Exhibit D Touchpanel Layouts

Exhibit D was updated on 4/8/24. There was text cutoff on the bottom of each picture in the published RFP for the pictures of the control station. This version of Exhibit D show the full text that was cutoff.

Audio Routing

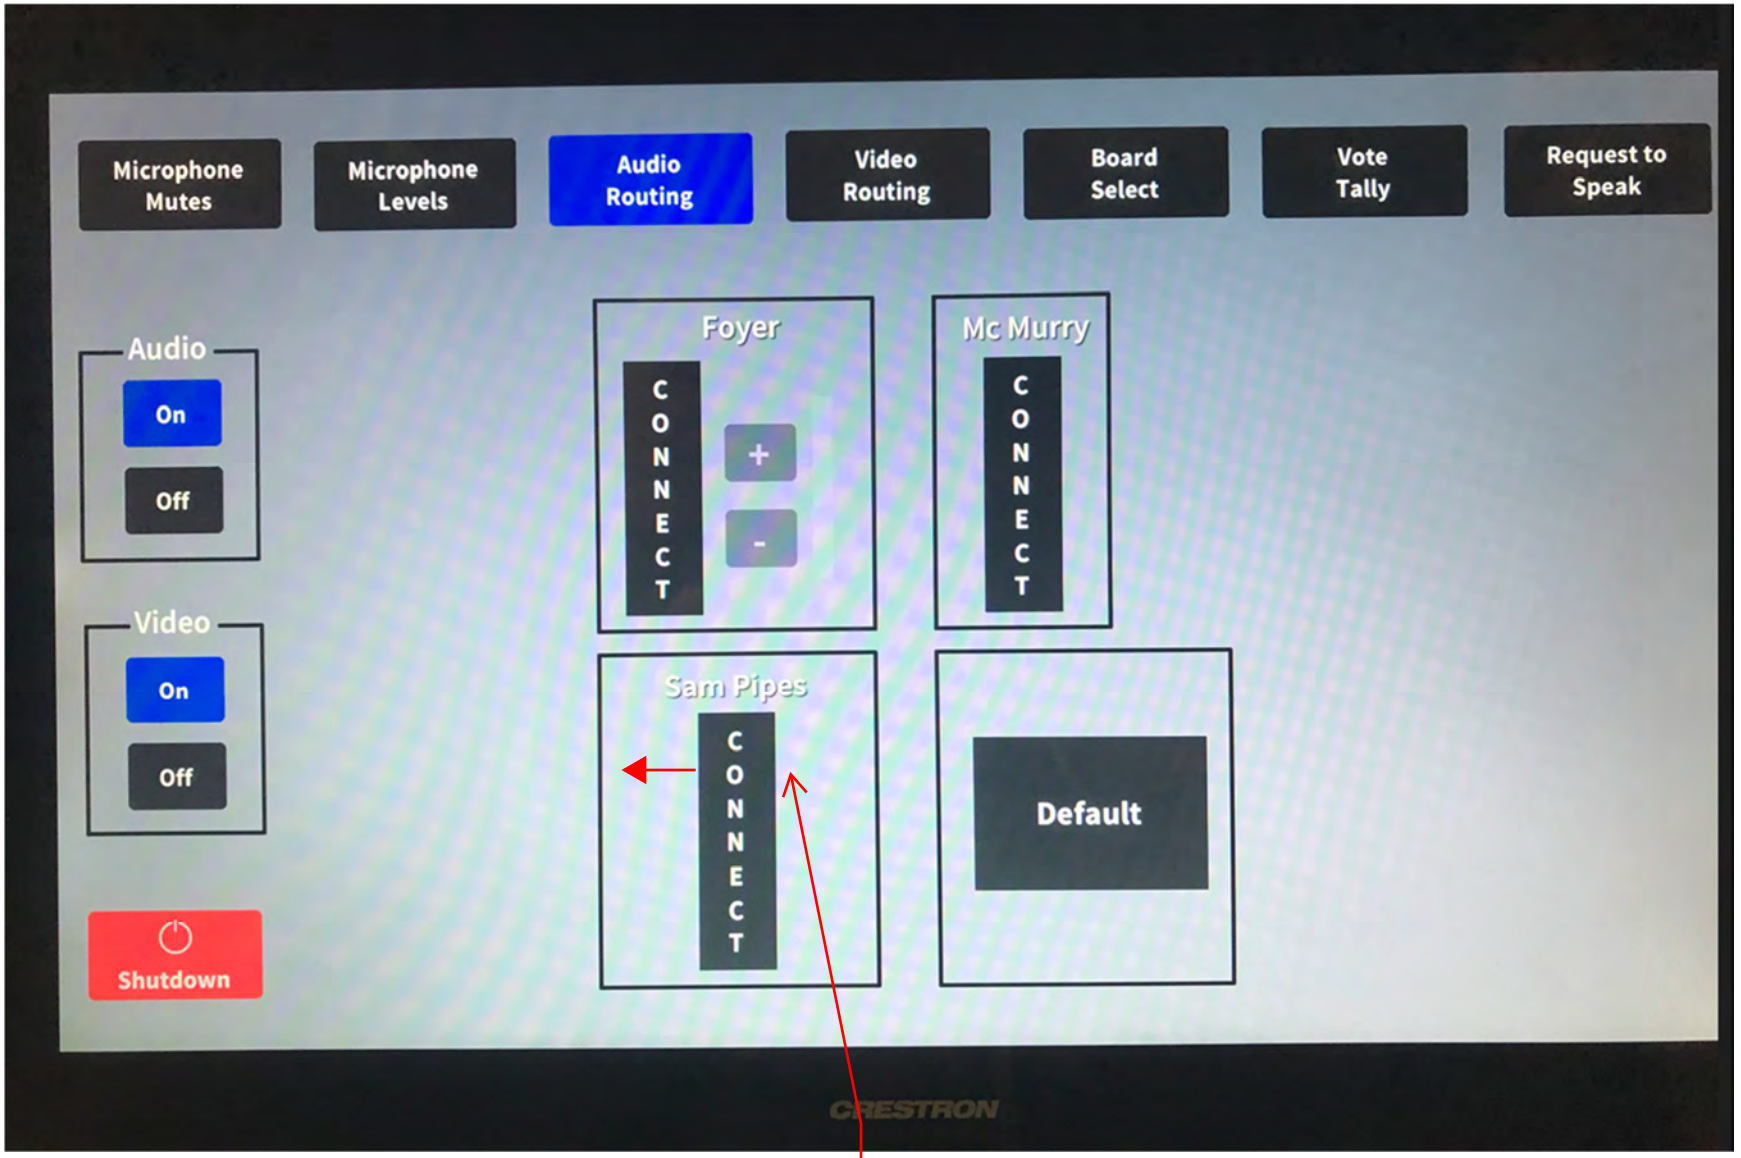
Move "CONNECT" button to the left; add "MEETING" button

Add additional page accessed when the "MEETING" button is used. Page to include level and mute buttons for "WL 5" AND "WL 6" and "Return to Audio Routing" button with an arrow

Mic Mutes

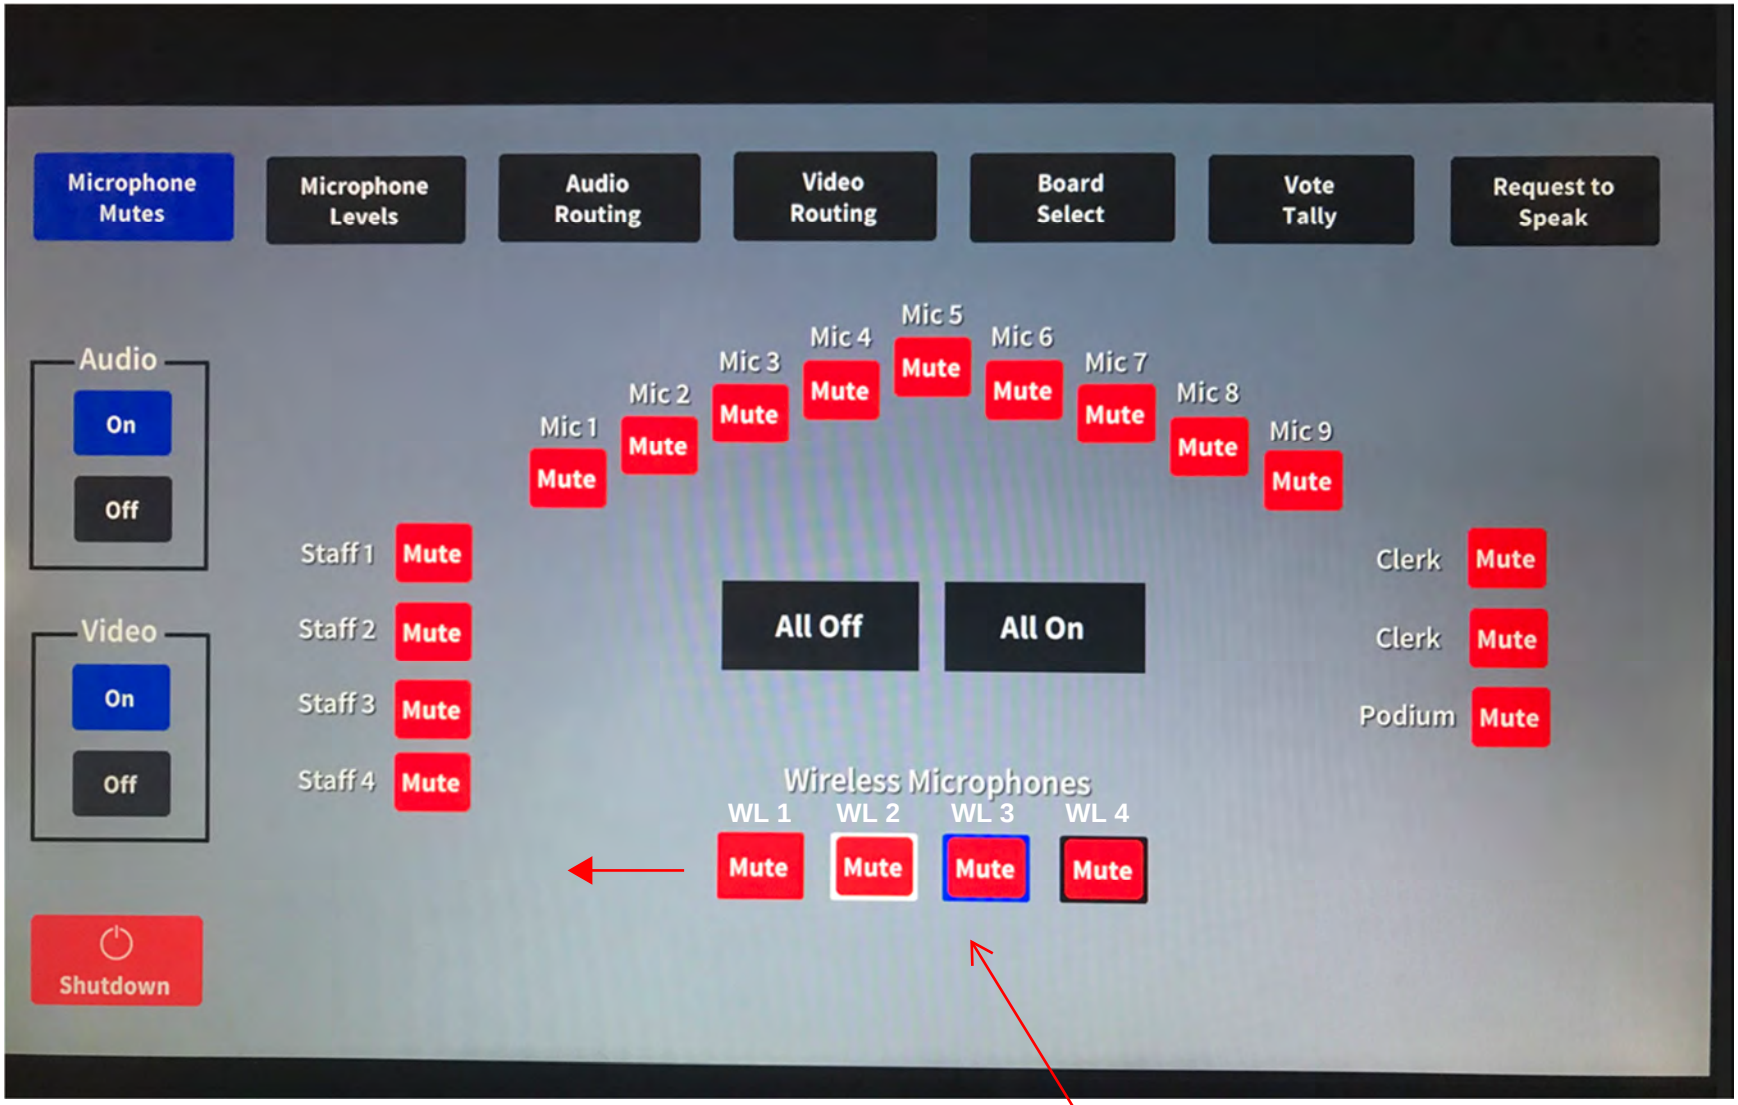
Add Wireless Microphones 5 and 6.
Move wireless 1-4 to the left to center all wireless mics on touch panel.
Include WL mic number above wireless mics. Use same font
Move "Wireless Microphones" label up to create room for "WL#" labels
